ADDENDUM #1

NORTH PLATTE COMMUNITY COLLEGE SOUTH CAMPUS CAFETERIA ADDITION NORTH PLATTE, NEBRASKA 1001

Date Issued: March 13, 2013

1/A1.0 FLOOR PLAN - FIRST FLOOR
 SCALE: 1/8" = 1'-0"

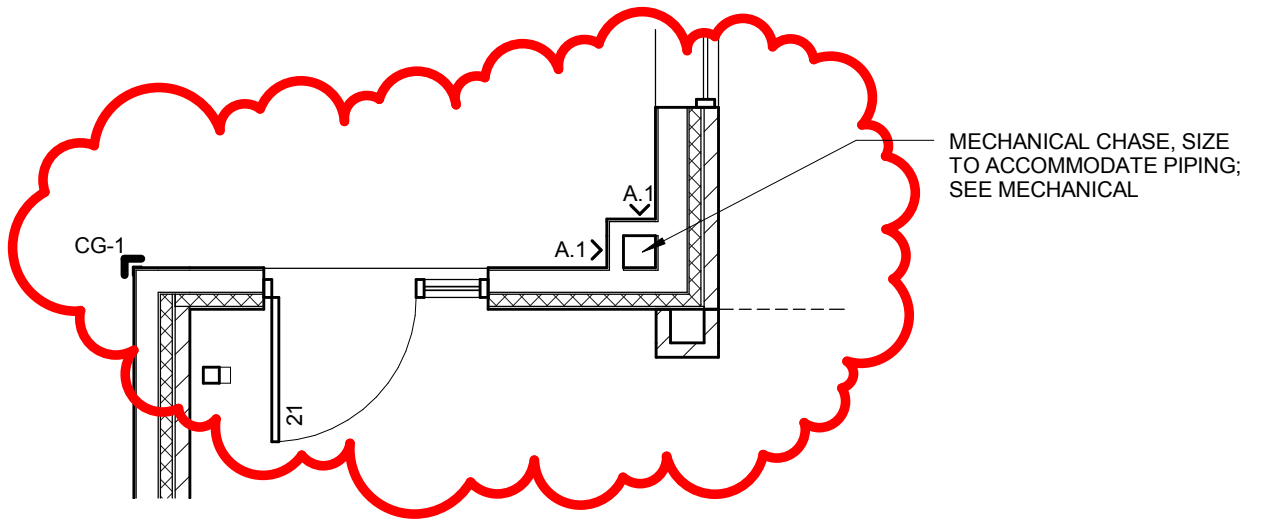
- Addendum #1 - #8 SHEET A1.0 – FLOOR PLAN**
1/A1.0 FLOOR PLAN: At DINING ROOM 21 add a mechanical chase in the southeast corner of the room as shown on Attachment A1 to Addendum No. 1 dated March 13, 2013.

2/A2.0 ENLARGED PLAN
 SCALE: 1/4" = 1'-0"

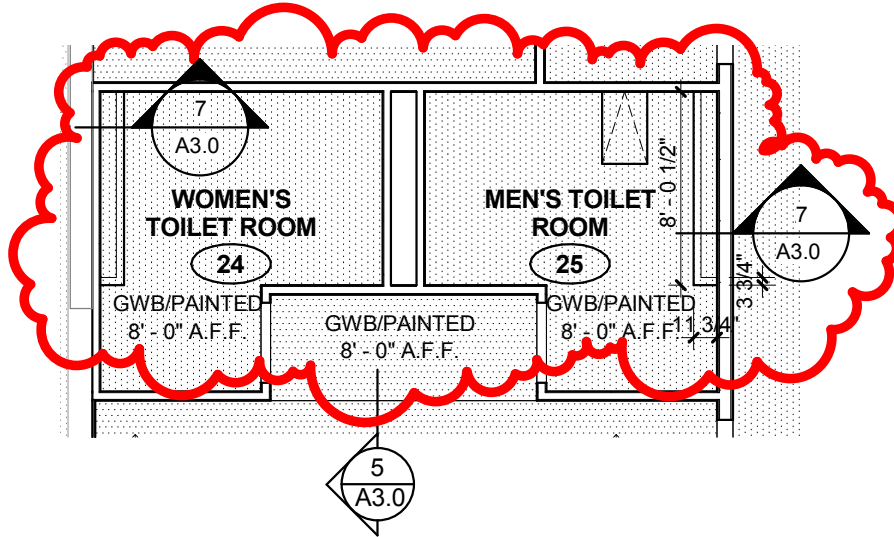
- Addendum #1 - #9 SHEET A2.0 – ENLARGED PLAN**
1/A2.0 ENLARGED PLAN: At DINING ROOM 21 add a mechanical chase in the southeast corner of the room as shown on Attachment A1 to Addendum No. 1 dated March 13, 2013.

- Addendum #1 - #10 SHEET A2.0 – ENLARGED PLAN**
1/A2.0 ENLARGED PLAN: At VESTIBULE 23 shift the north most automatic door push button further south so that it is 12” north of the south most automatic door push button.

1 **1/A3.0 REFLECTED CEILING PLAN**
 A2 SCALE: 1/8" = 1'-0"

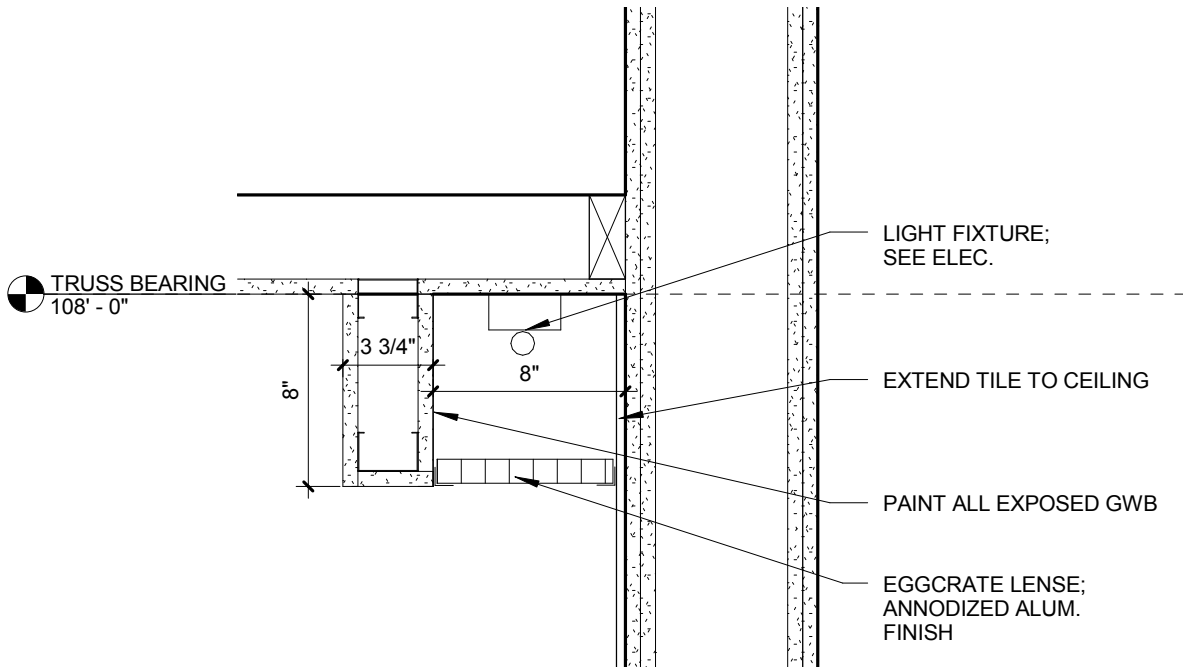
- Addendum #1 - #11 SHEET A3.0 – REFLECTED CEILING PLAN**
1/A3.0 REFLECTED CEILING PLAN – FIRST FLOOR: Add new bulkhead with recessed light fixture(see electrical) above countertops in WOMEN’S TOILET ROOM 24 and MEN’S TOILET ROOM 25 as shown on Attachment A2 to Addendum No. 1 dated March 13, 2013.

- Addendum #1 - #12 SHEET A3.0 – REFLECTED CEILING PLAN**
Add to sheet A3.0 detail 7/A3.0 CEILING DETAIL as shown on Attachment A2 to Addendum No. 1 dated March 13, 2013.

Sheet Number: E6.1

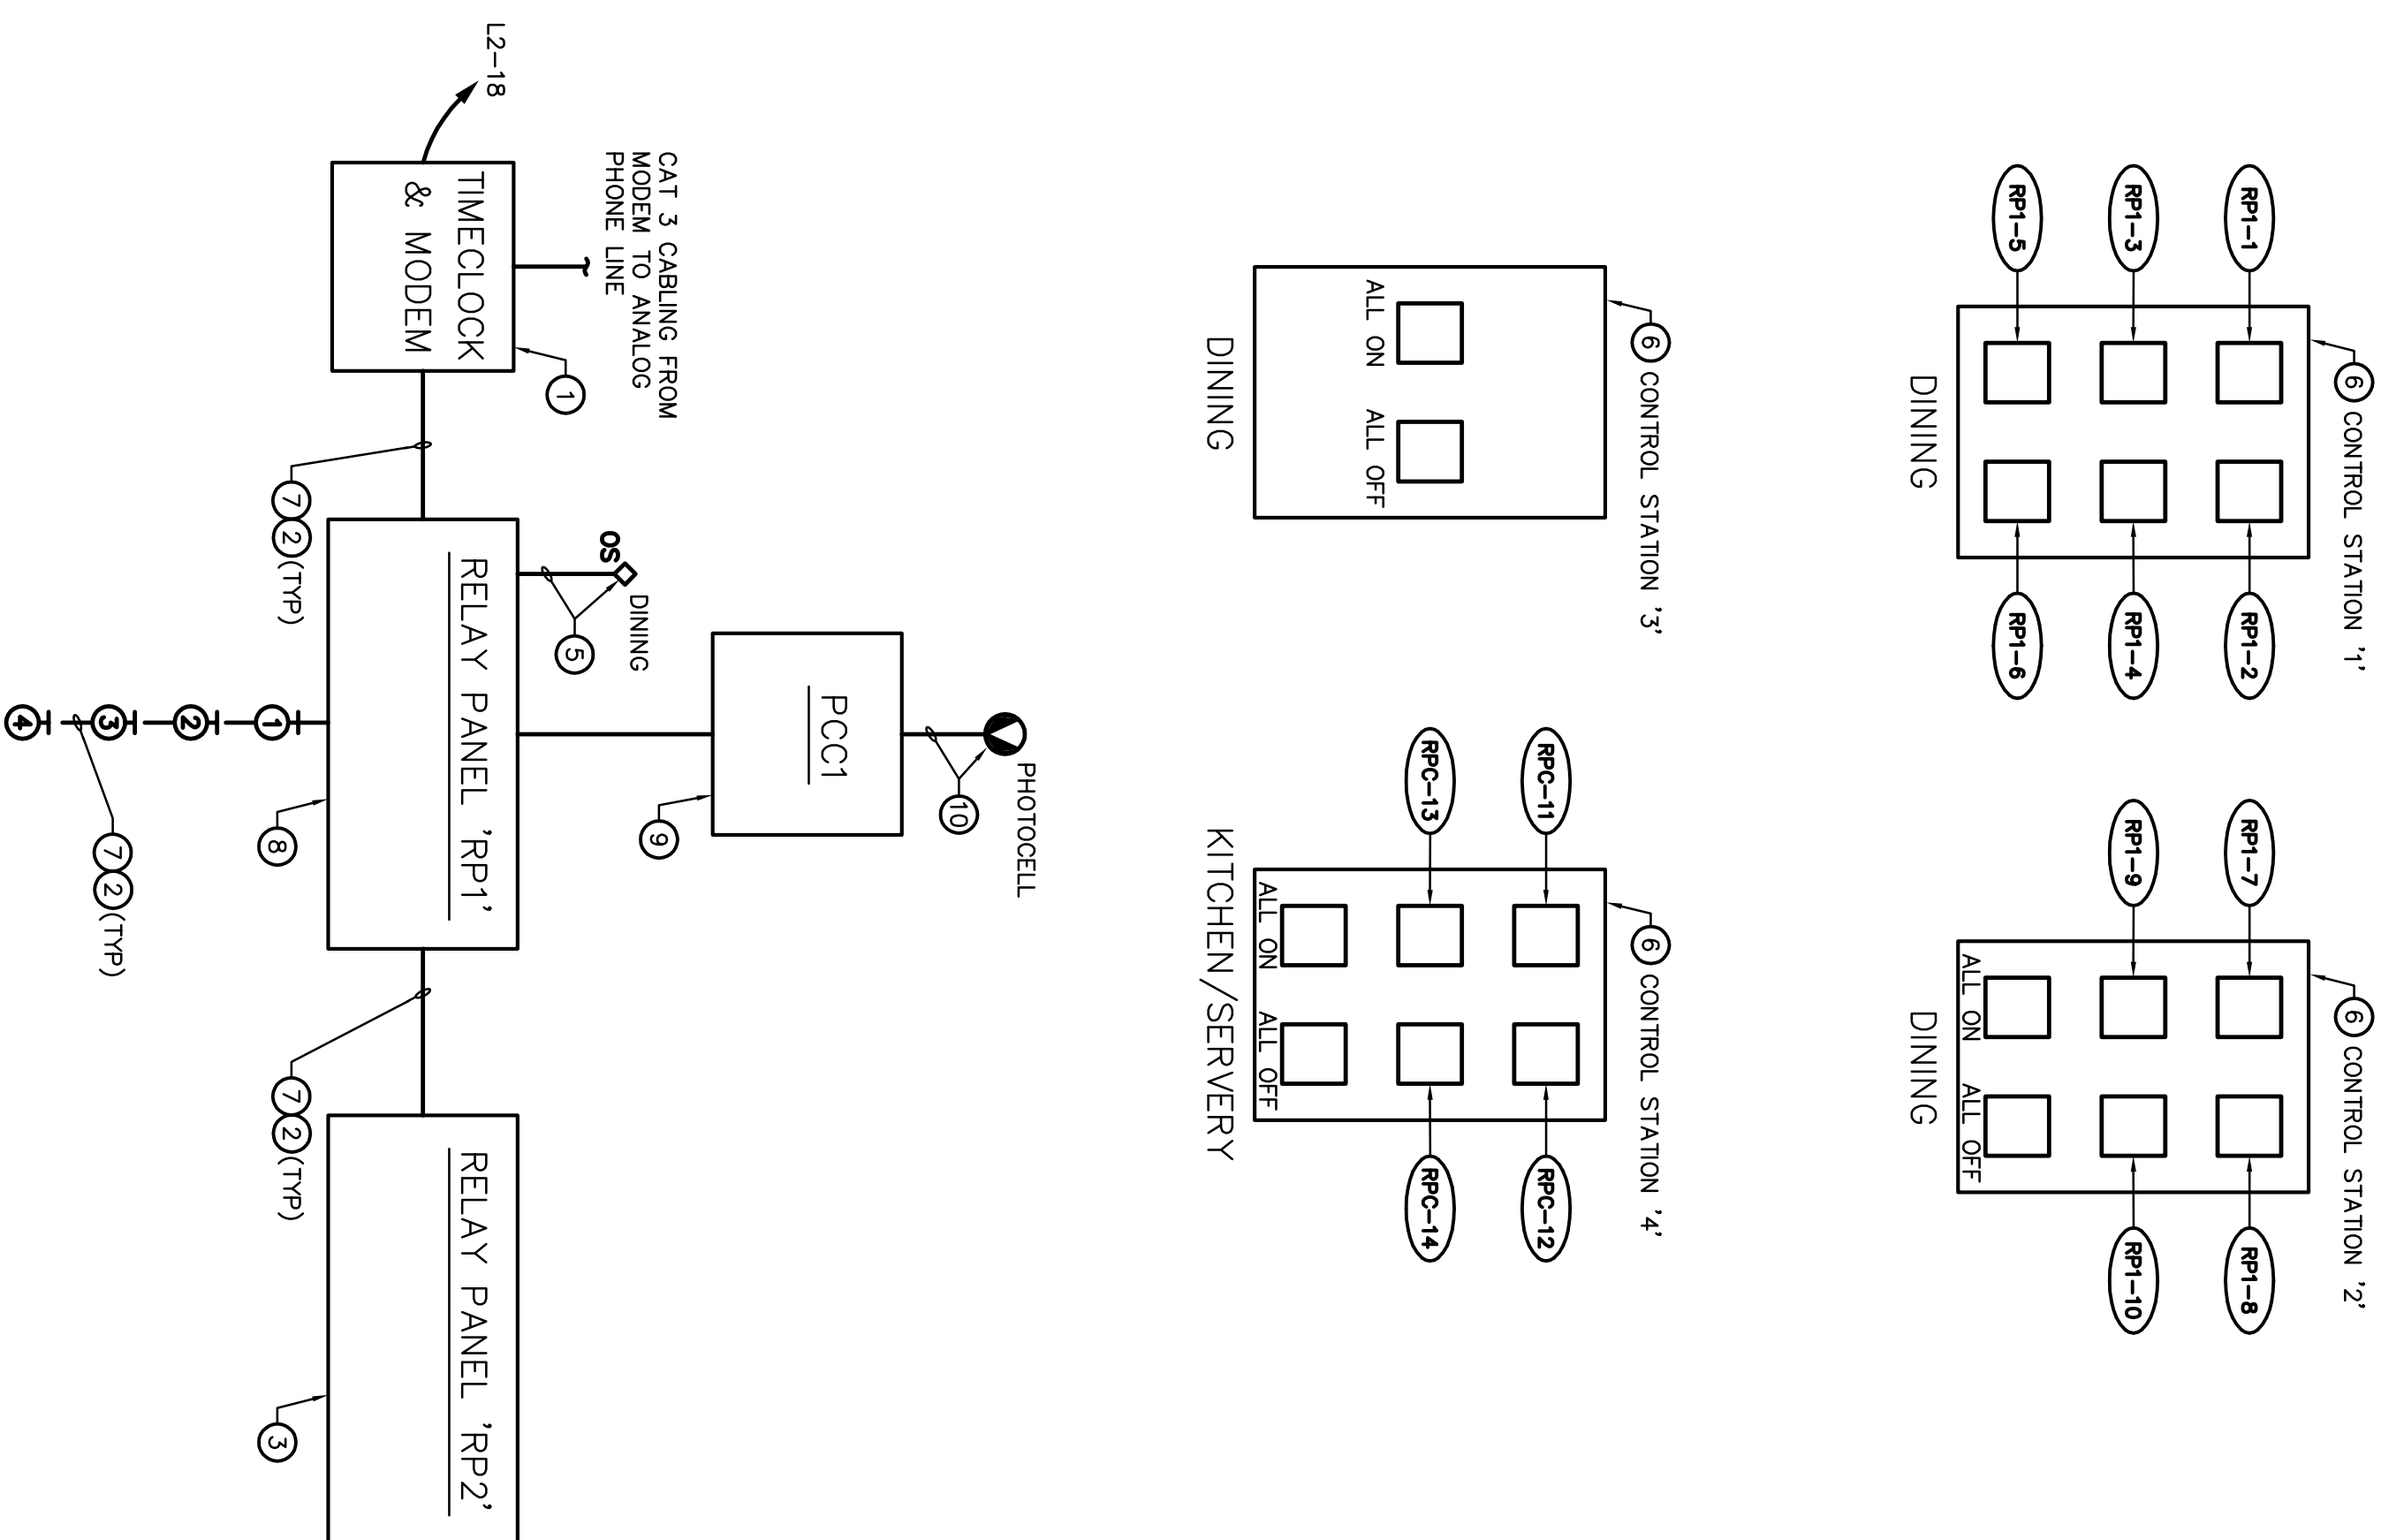
- Addendum #1 - #18 SHEET E6.1 – ELECTRICAL SCHEDULES**
See the revised sheet for changes to the relay panel and luminaire schedules.
- Addendum #1 - #19 SHEET MH1.1 – HVAC PLAN – FIRST FLOOR**
Add the following to keynote #6: “Paint ductwork exposed to exterior. Coordinate paint color and requirements with architect.”
